Hines and Jones Hall Refresh
ISU Bid #B0028696

12/23/2025

This Addendum issued prior to bidding, alters, amends, corrects or clarifies the Proposal Documents to the extent stated herein and does hereby become a part of the Proposal Documents, and will become a part of the Contract Documents of the successful bidder.

P301H

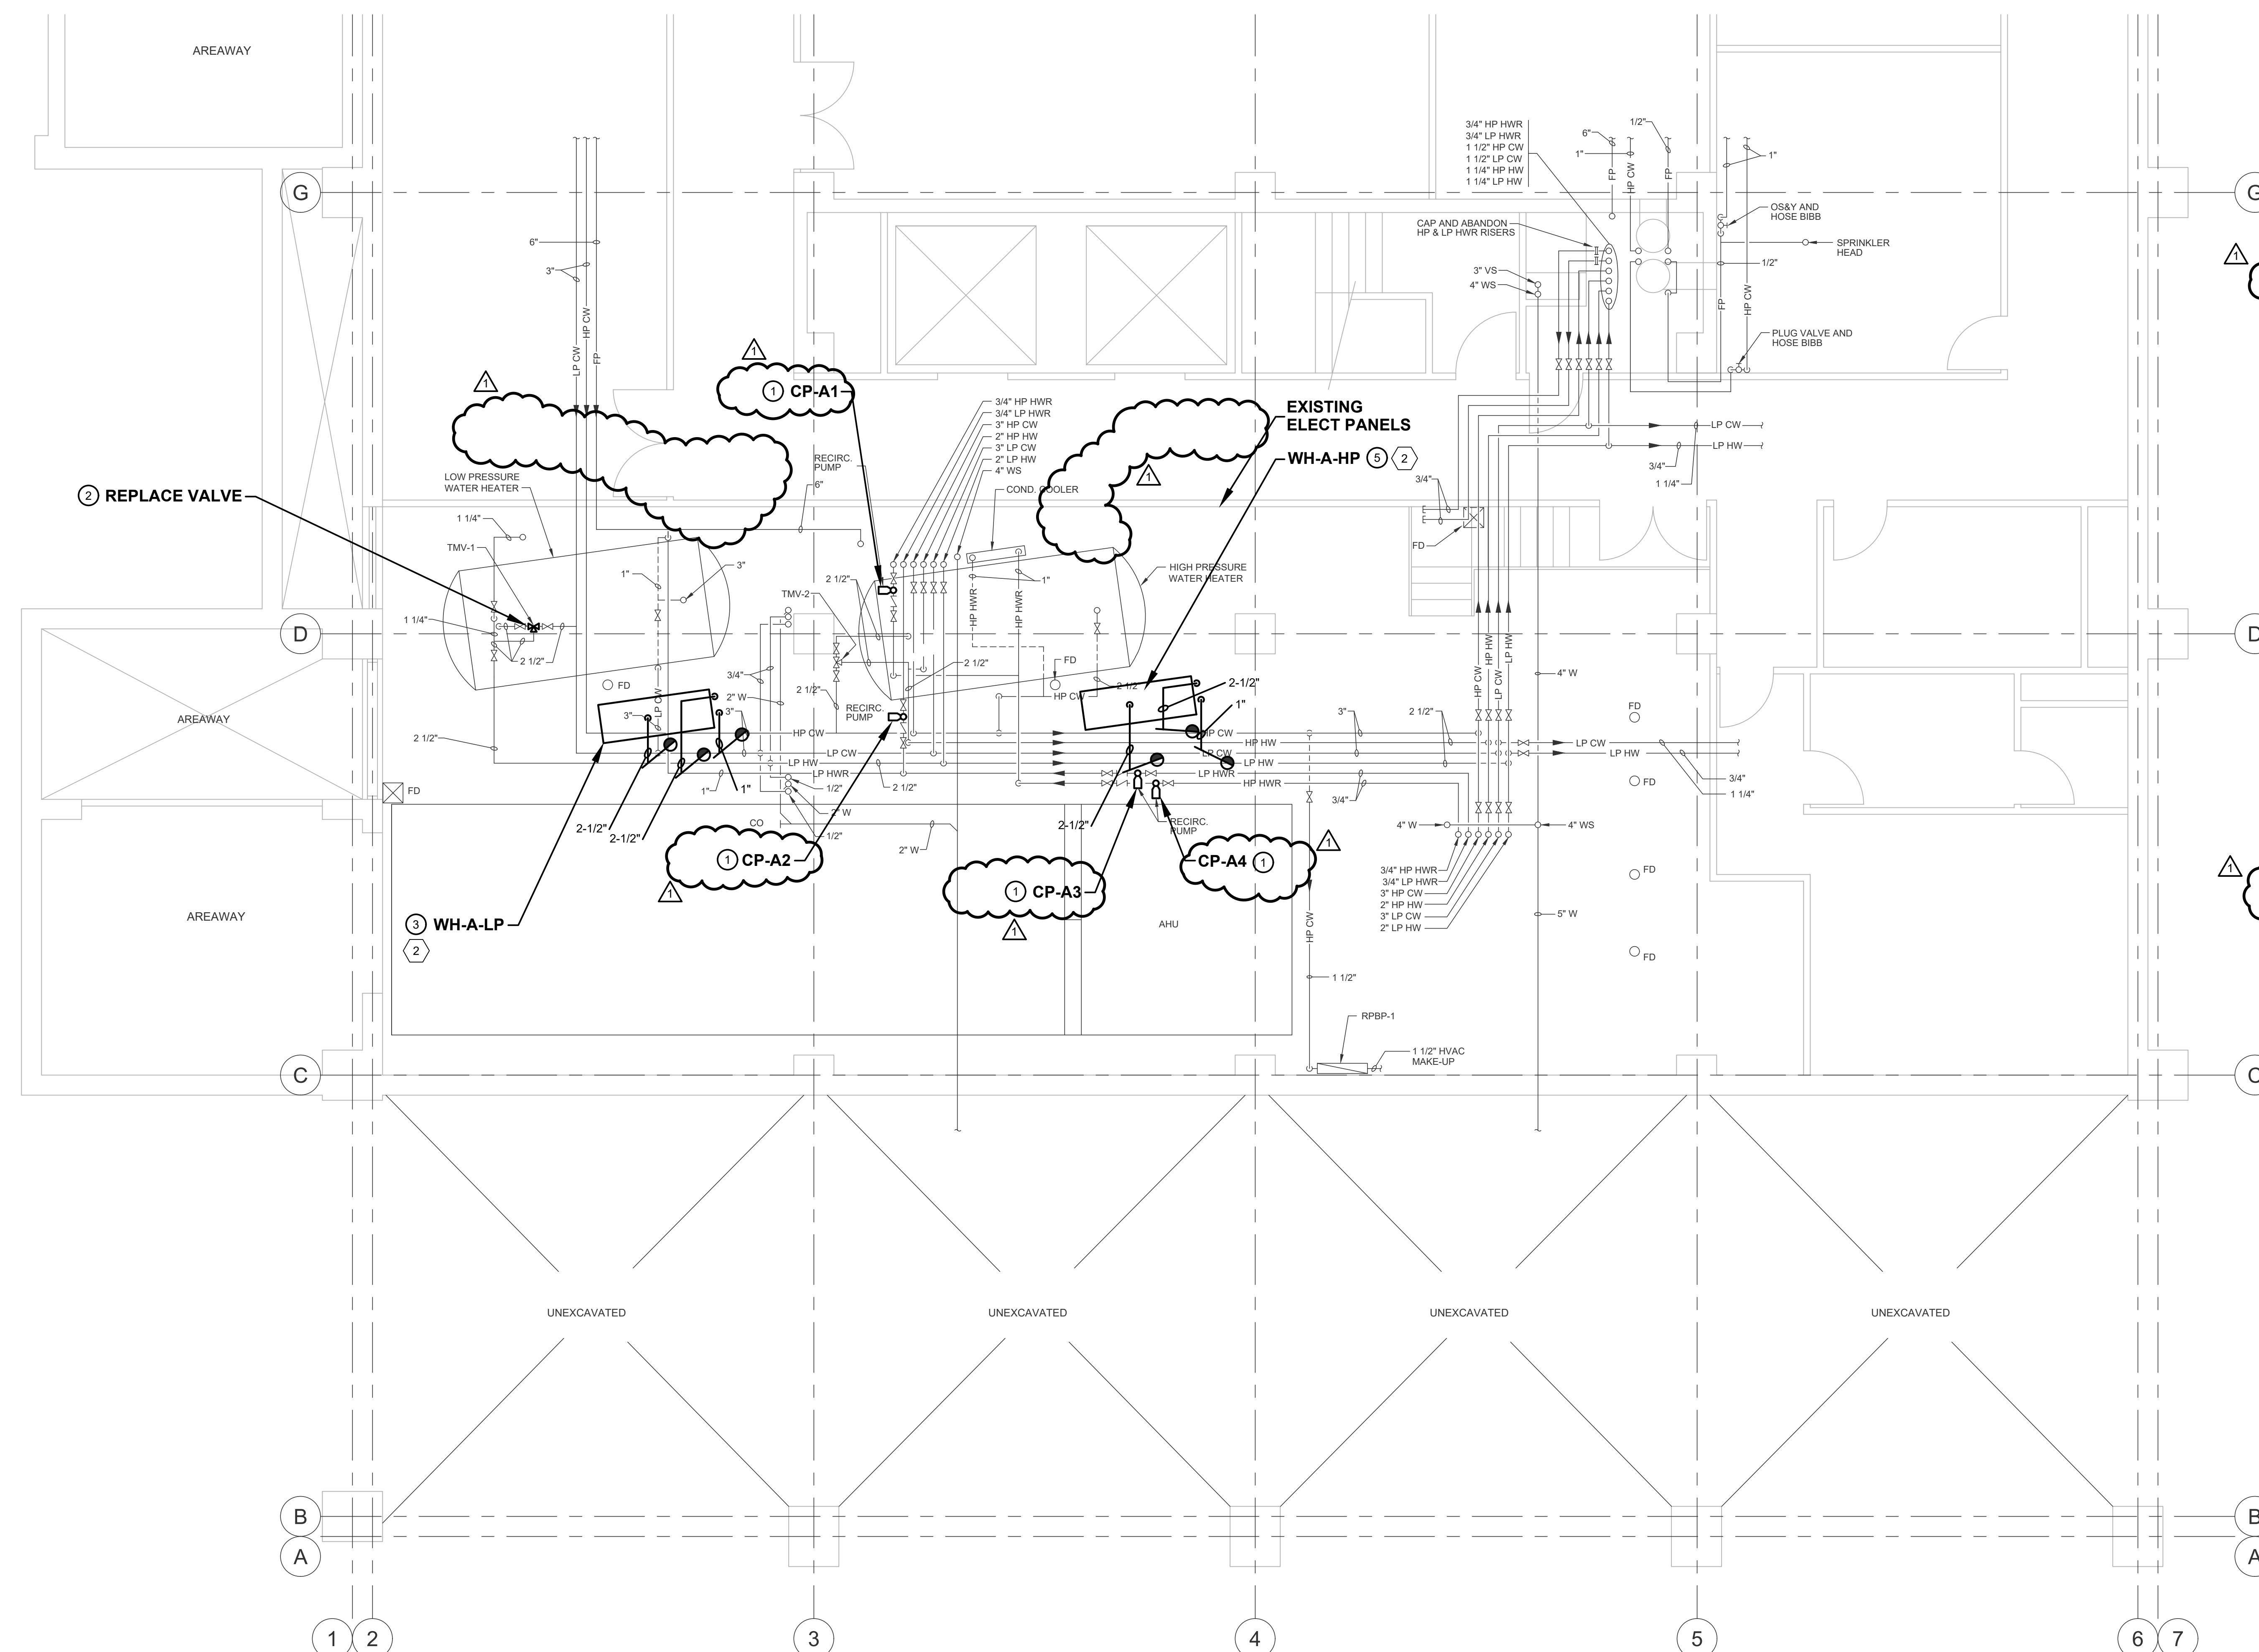
2. Drawing P204 – Tenth Floor – Plumbing
 - a. Identifies fixture types.
3. Drawing P301H – Hines Basement - Plumbing
 - a. Re-issued to clarify work to circulation pumps.
4. Drawing P301J – Jones Basement – Plumbing
 - a. Re-issued to clarify work to circulation pumps.
5. Drawing P401 – Schedules and Details – Plumbing
 - a. Re-issued to add Shower Cover Plate detail.
6. Drawing P621H – Hines Work Schedule – Plumbing
 - a. Re-issued to clarify work to shower valves.
7. Drawing P621J – Jones Work Schedule – Plumbing
 - a. Re-issued to clarify work to shower valves.

- 1 TEST CIRCULATION PUMP. CONFIRM PROPER OPERATION WITH ANOMETER.
- 2 REPLACE THERMOSTATIC MIXING VALVE. REPLACE ALL RELATED CALCULUS BUILDUP. IF LOW PRESSURE STEAM WATER HEATER ALTERNATE IS ACCEPTED. THIS WORK IS NOT TO BE COMPLETED.
- 3 **ALTERNATE**
INSTALL NEW INSTANTANEOUS STEAM WATER HEATER FOR LOW PRESSURE DOMESTIC WATER. SEE M-SERIES DRAWINGS FOR STEAM CONNECTIONS AND DETAILS.
- 4 **ALTERNATE**
REMOVE STEAM TANK LP WATER HEATER.
- 5 **ALTERNATE**
INSTALL NEW INSTANTANEOUS STEAM WATER HEATER FOR HIGH PRESSURE DOMESTIC WATER. SEE M-SERIES DRAWINGS FOR STEAM CONNECTIONS AND DETAILS.
- 6 **ALTERNATE**
REMOVE STEAM TANK HP WATER HEATER.
